Del's Hidaway

Administrative Amendment Request

Project #PR 2020-004225 SI-

Transportation Development Comments:

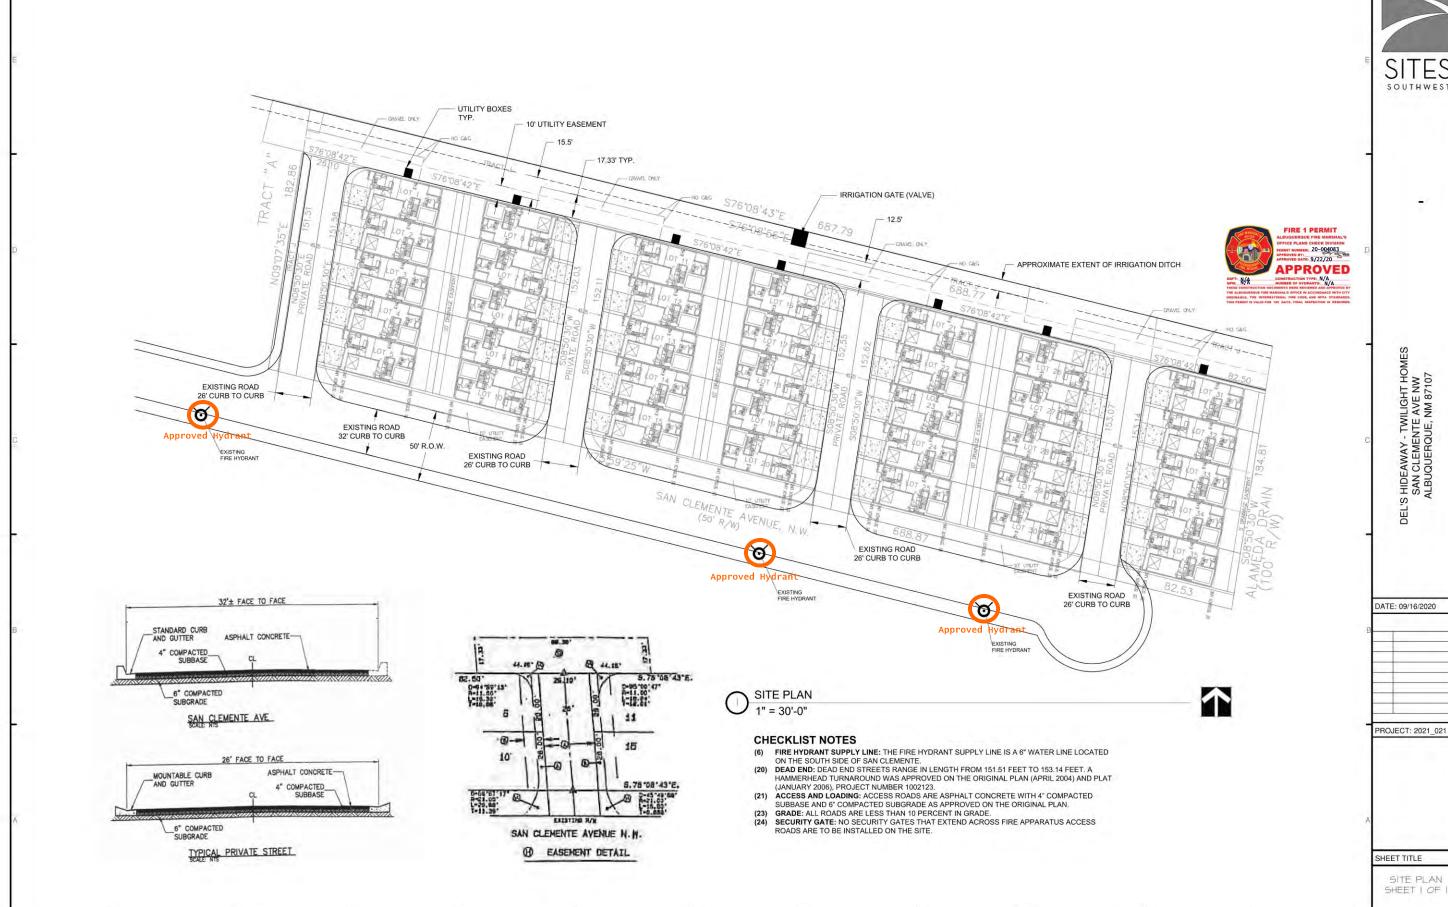
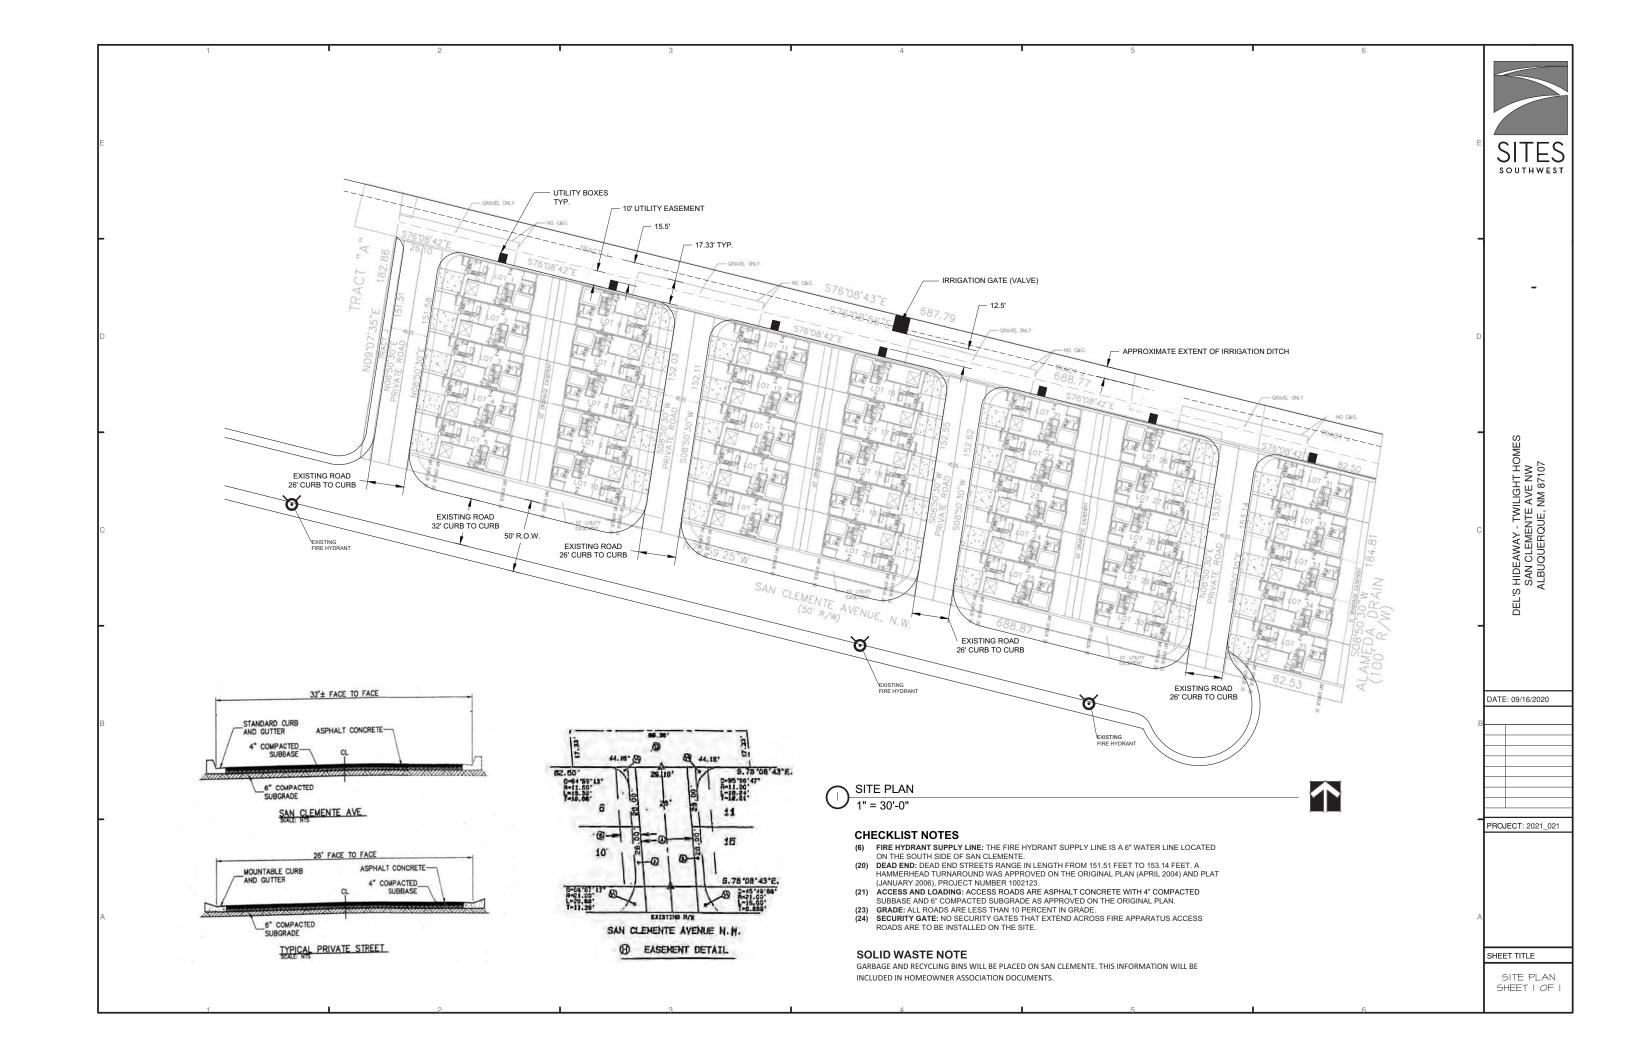
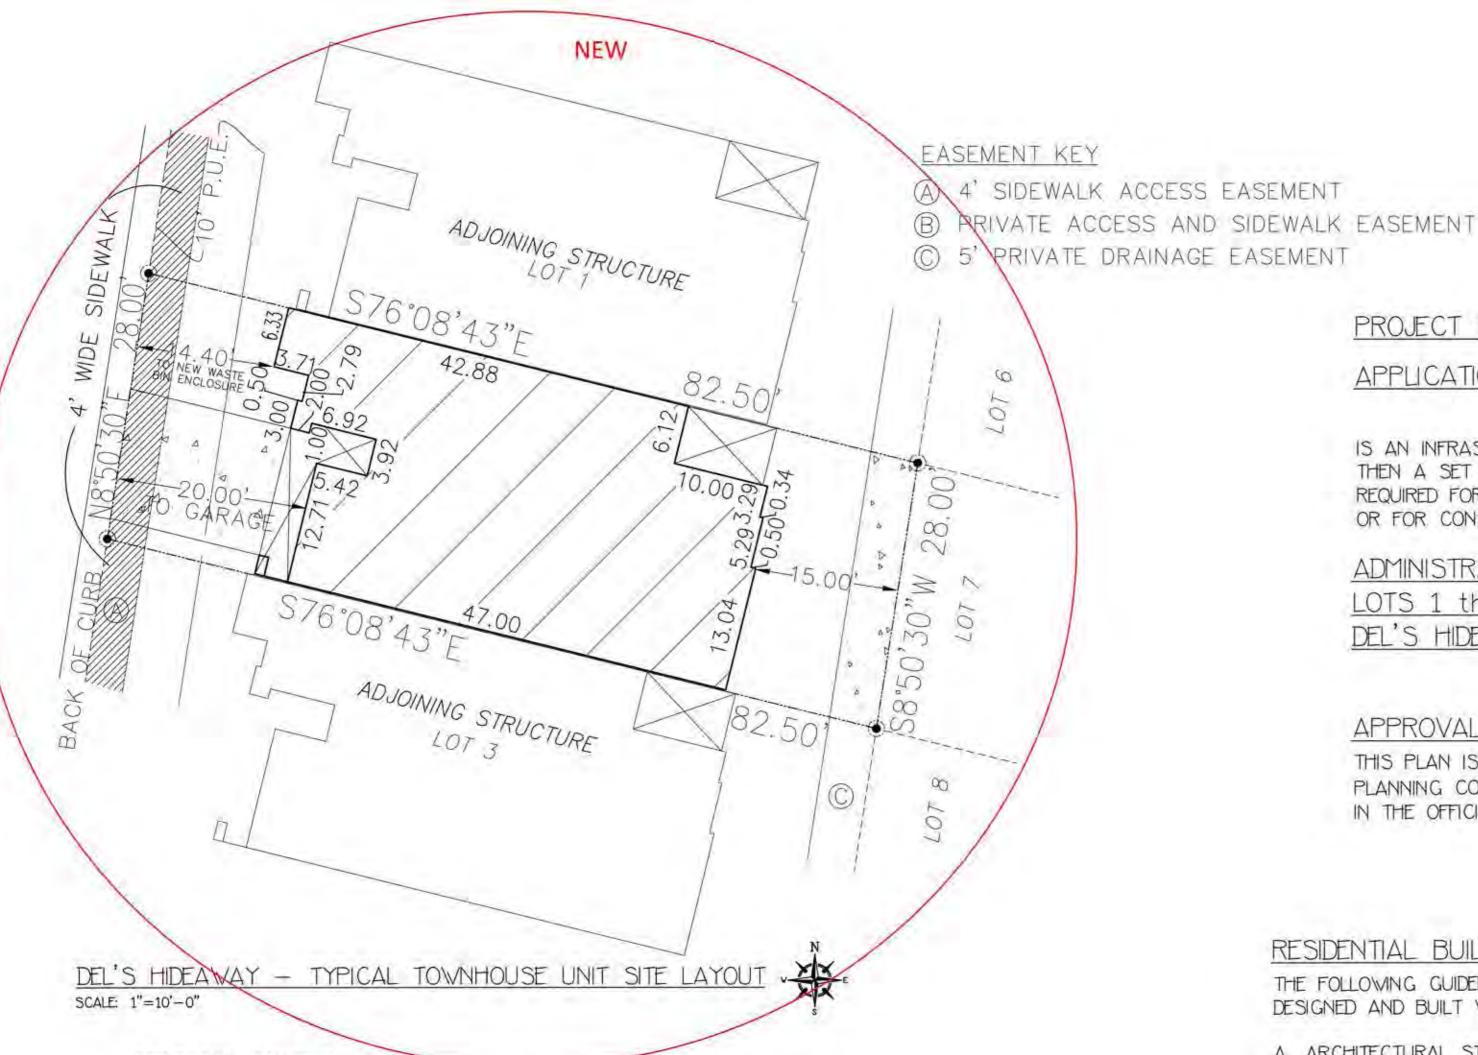
- Obtain Solid Waste and Fire Marshall approval for the proposed site plan.
- Since site plan was approved, requirements for turn-arounds have changed for trucks.
 Additional surfacing for the hammerheads appears to be needed. Refer to drawing below for required dimension for a turn-around.

- Provide plat indicating any private easements with the submittal. Accessways would need to be contained within these easements.
- Show sidewalk and sidewalk width along San Clemente and along any private easements. Per DPM, sidewalk is required along both public right-of-way and private easements serving multiple lots.
